Common Errors Seen in Plan Review

Melissa Effinger, P.E. – Michael Baker Intl.

Rebecca Camarata, P.E. – INDOT

From Std. Dwg. 601-RHPG-06

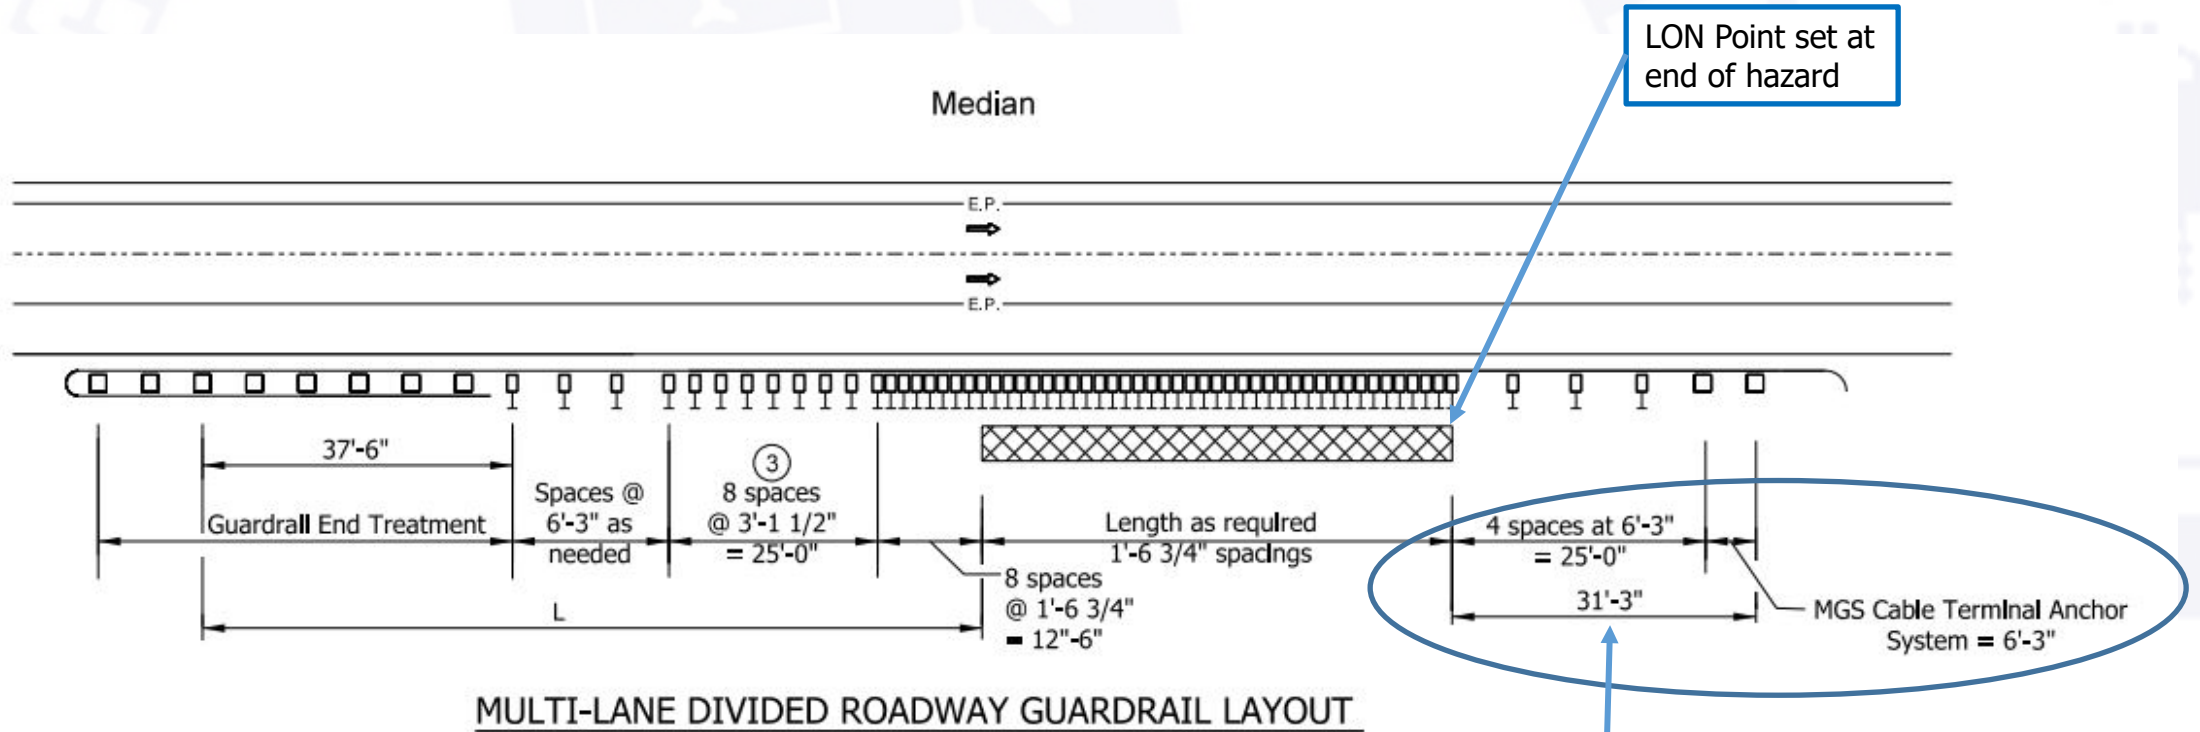
- LON Calculation beyond Hazard at or Inside of the Working Width
 - Use layout with Standard Drawing series 601-RHPG

The length of guardrail beyond the length of need should be 31'-3", per Design Memo 17-10, which includes the length of the MGS W-Beam Cable Terminal Anchor

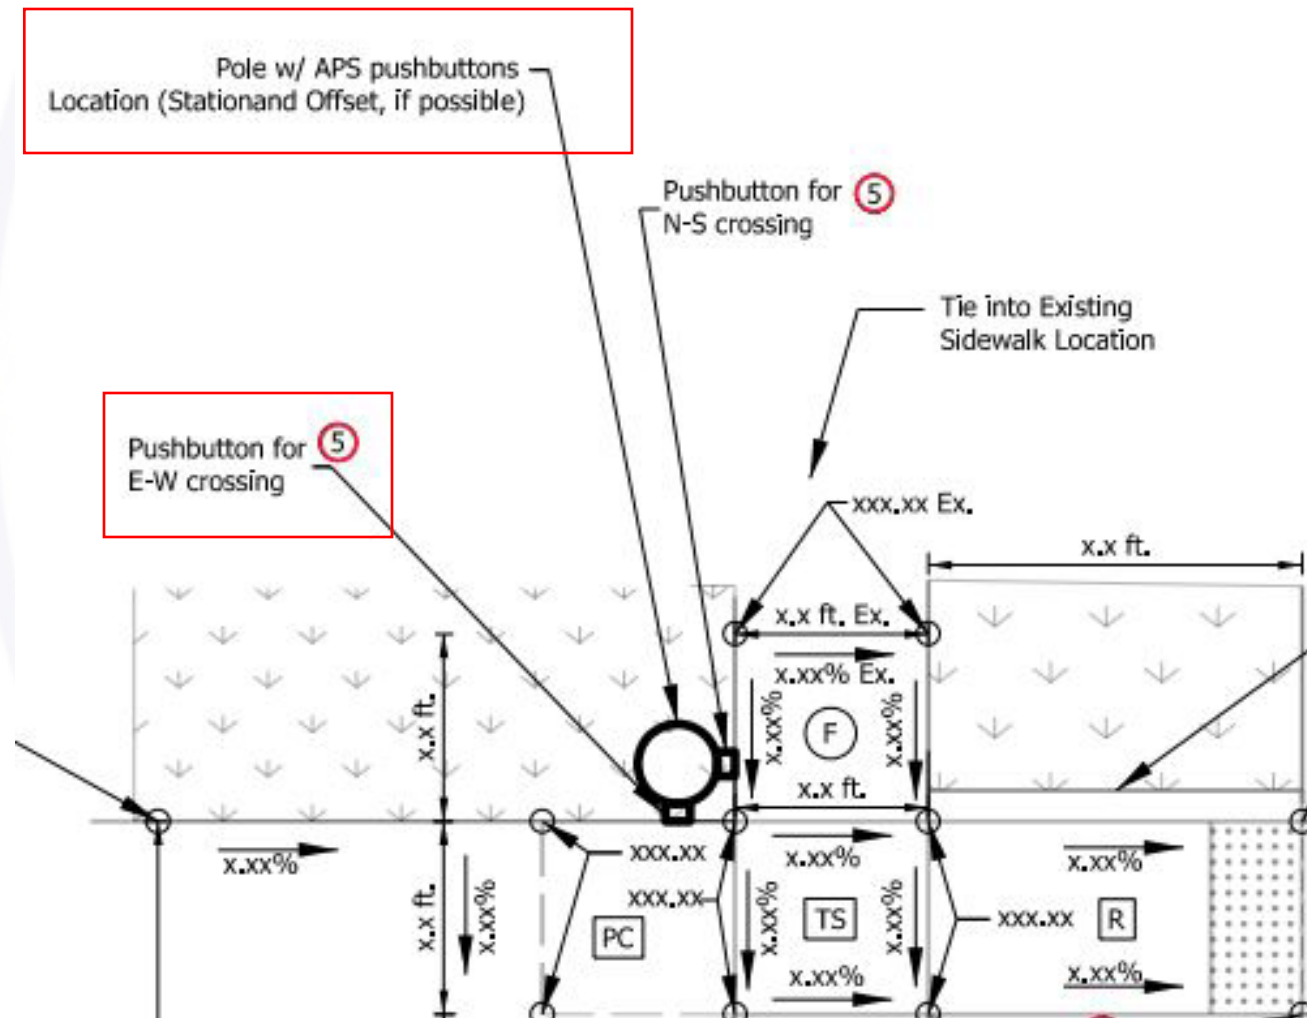
- ① Required where the pedestrian clear space does not overlap a turning space, level ramp, or a well defined and level sidewalk.
- ② Elevation to be flush with ramp.
- ③ Elevation to be flush with roadway.
- ④ The curb ramp should be labeled to include the curb ramp type.
- ⑤ Pushbutton note should call for crossing direction and any adjustments to mounting height and side reach. If an extension is required for side reach the length should be noted. If no adjustments are required for mounting height or side reach, this should also be included in the note.
- ⑥ Dimension the length of the curb transition, in addition to all other lengths.

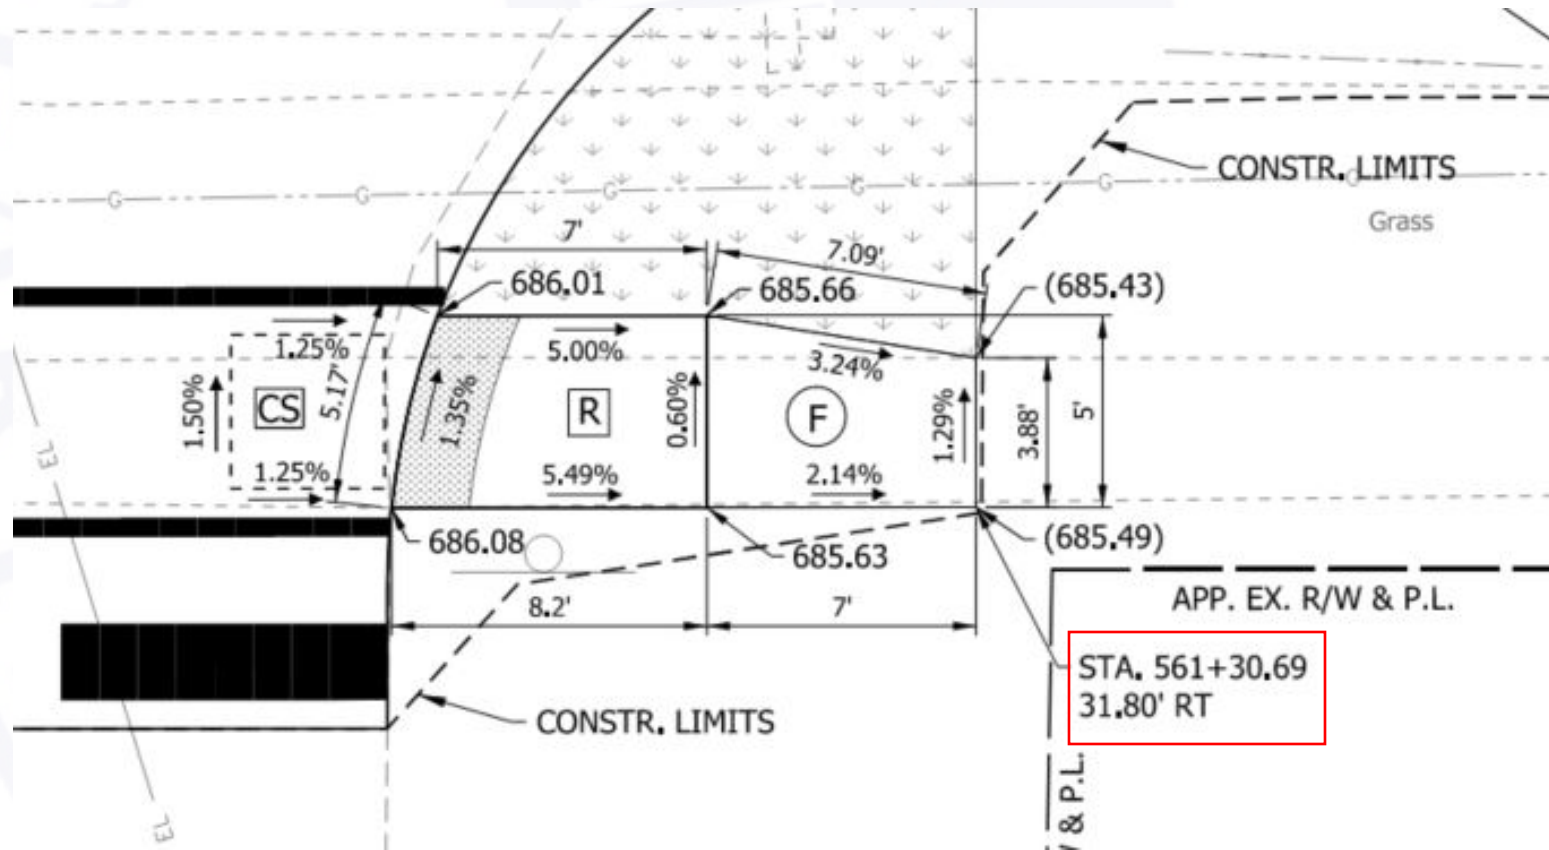
- ADA Curb Ramp Plan Details – Don't forget to locate the curb ramp with station/offsets or N/E at key points

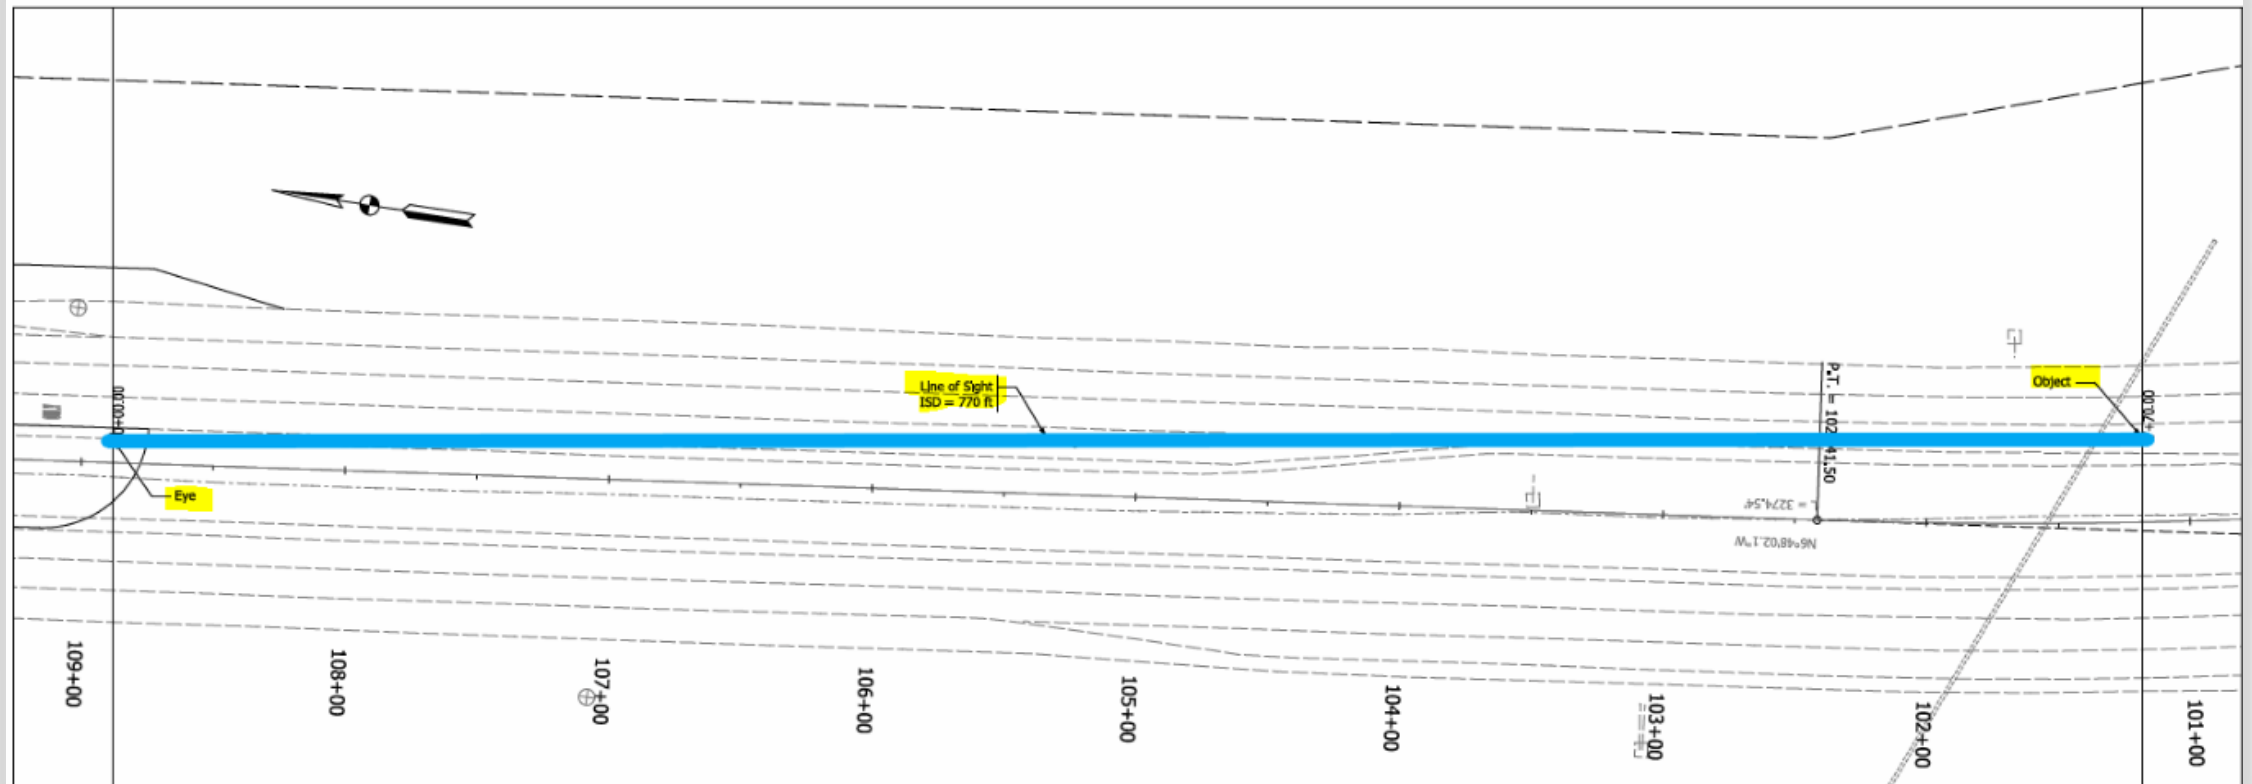
- Common errors found during plan review
 - Eye locations placed incorrectly
 - Profile under sight lines not included
 - ISD not being checked where required
 - Sight lines noted as meeting ISD when it is restricted

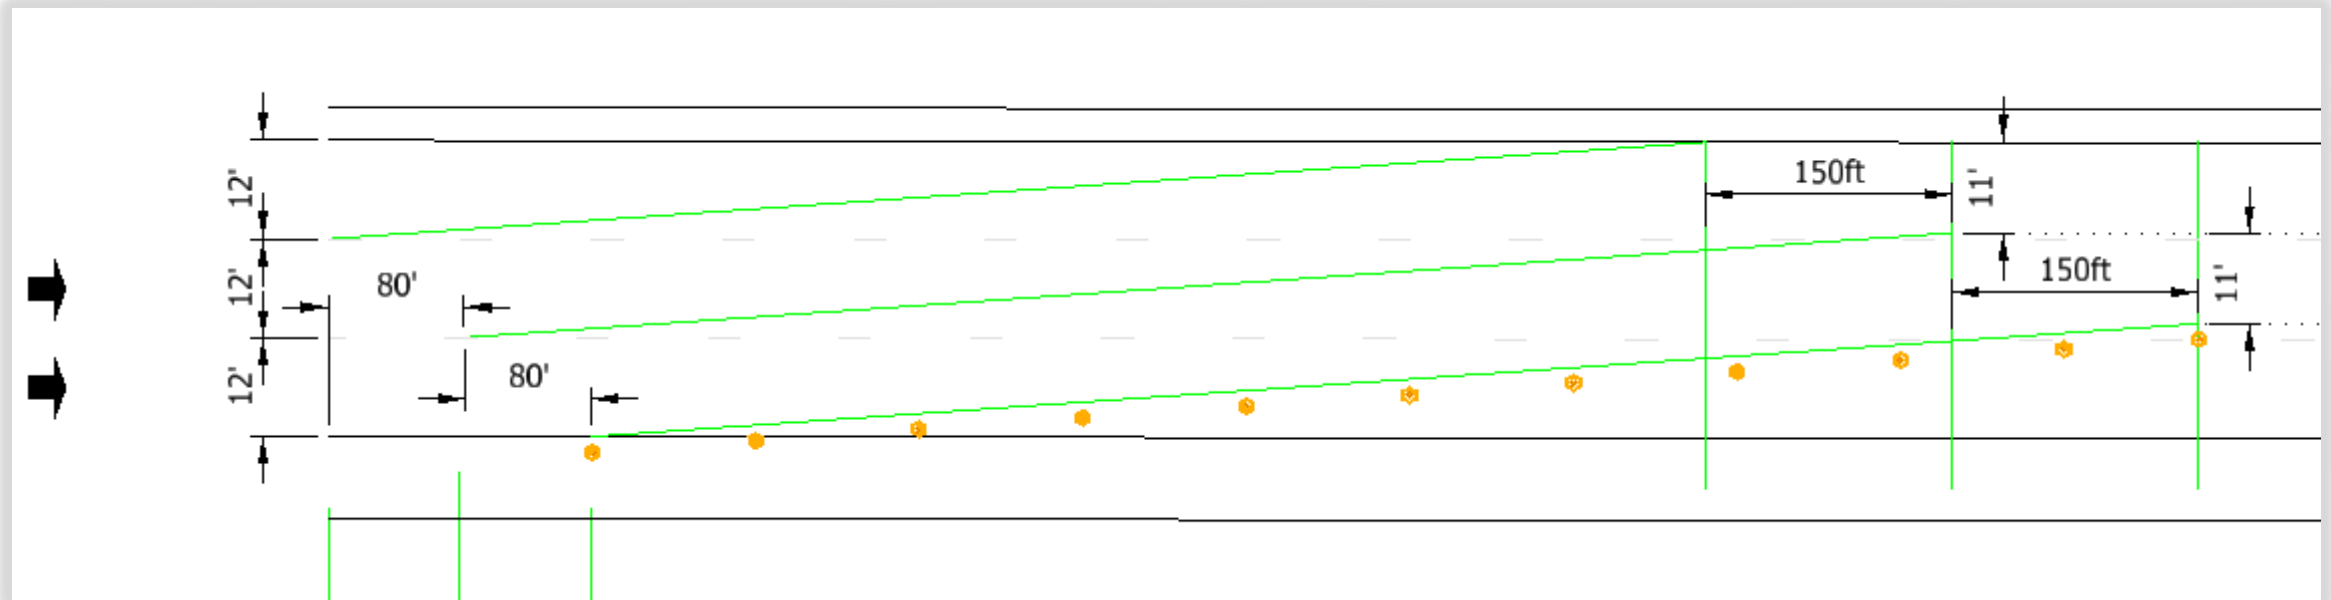
⑥ Unless otherwise specified on the plans, stagger lane shift to increase lane width through the shift. The temporary lane line in the middle shall be offset 40 ft from each temporary edge line for 12 ft lanes, see Detail A. For double lane shifts that go from 12 ft lanes to 11 ft lanes, the temporary lane line in the middle shall be offset 80 ft from each temporary edge line.
